# PARTS & SERVICE NEWS

REF NO.	AA02076
DATE	March 07, 2002

**SUBJECT:** WHEEL MOTOR DRAIN PLUGS

**APPLICATION:** Komatsu 930E Dump Trucks AFE48-A & Up, A30019, A30026 & Up

FIGURE 1. WHEEL MOTOR CUTAWAY

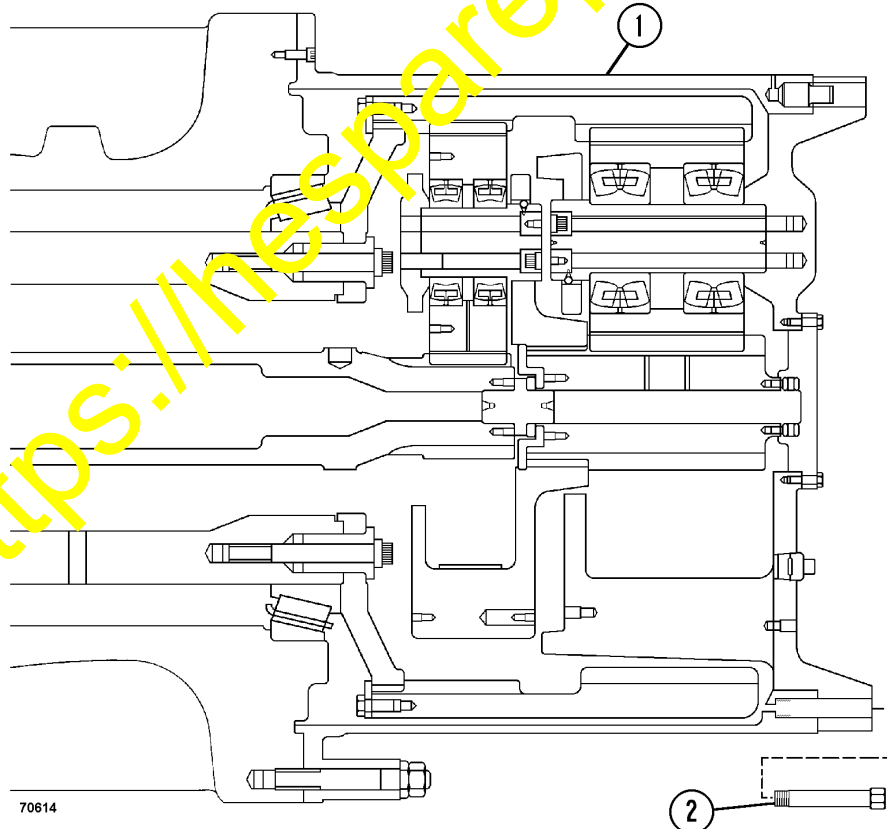
A new one piece drain plug (2, Figure 1) is now available for decreasing draining time. The new plug replaces the older, two piece, pipe and cap design. The part number of the new drain plug is GE0829.

When draining oil from the wheel motor, rotate one of the drain plugs to the six o'clock position on the wheel. This position allows the greatest amount of oil to drain from the assembly.
